**NORTHEAST UTILITIES**

August 17, 1982

**NORTHEAST UTILITIES QUALITY ASSURANCE PROGRAM**  
**TOPICAL REPORT REV. 4A**

FIGURE 1.1

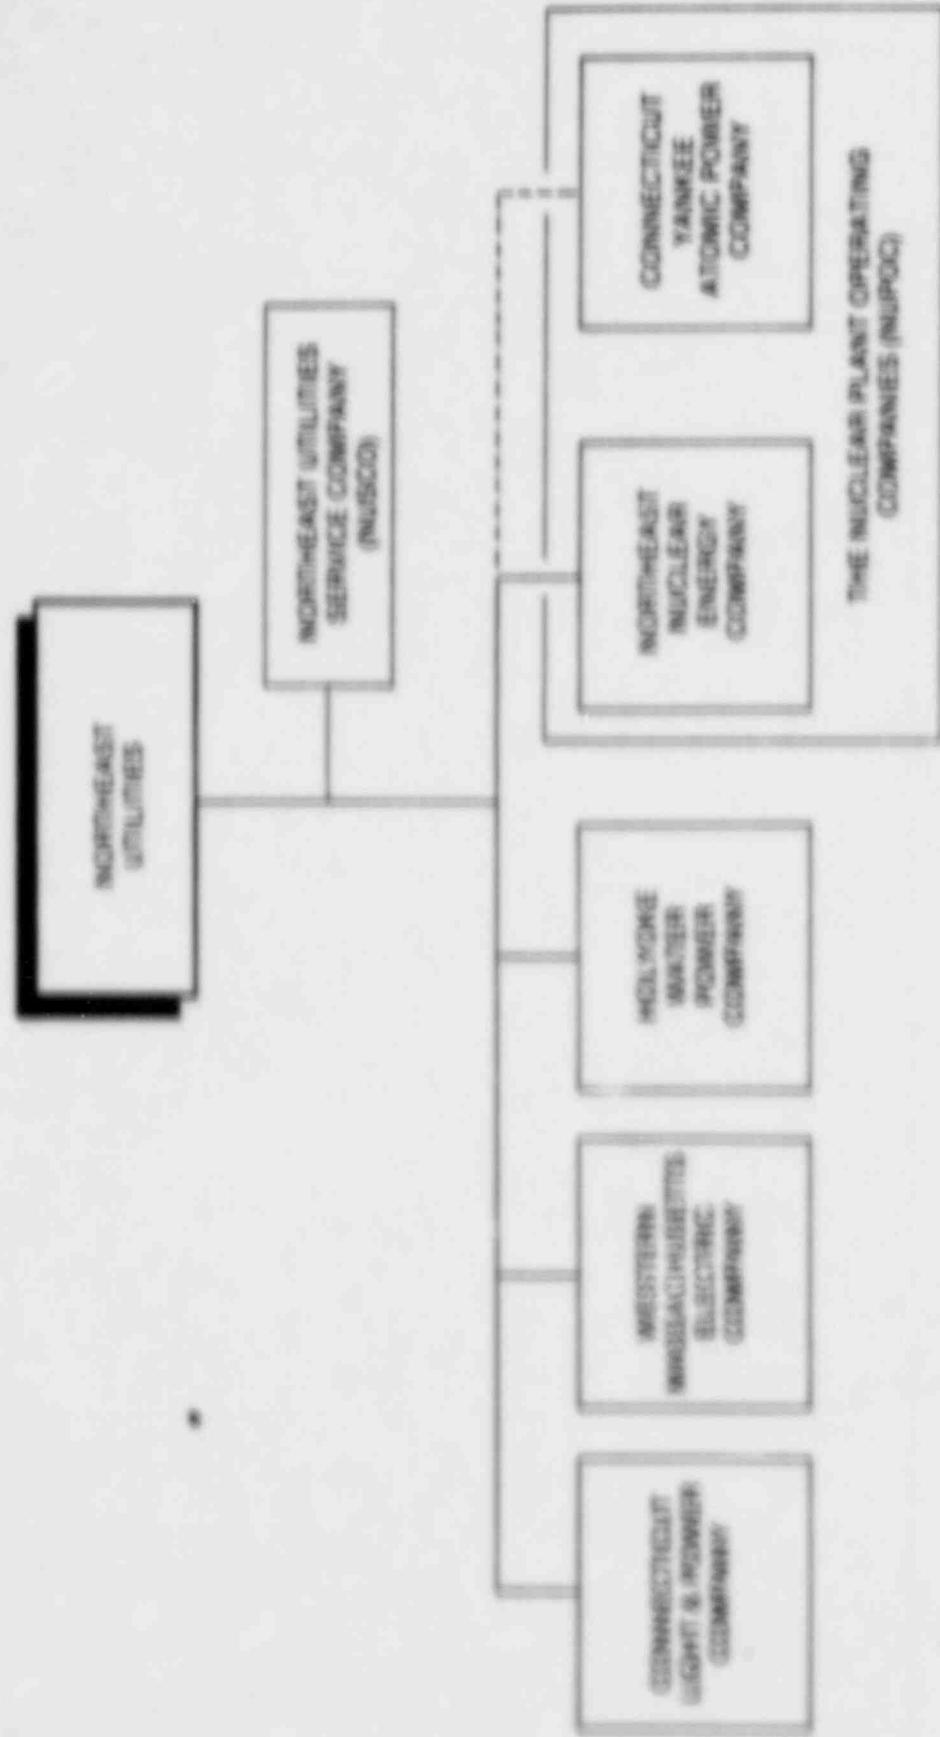
- \* Paragraph 1.1: The reference to The Hartford Electric Light Company (HELCO) will be deleted.
- \* Figure 1.1: The Hartford Electric Light Company will be deleted from the Northeast Utilities organization chart. A revised Figure 1.1 is attached.
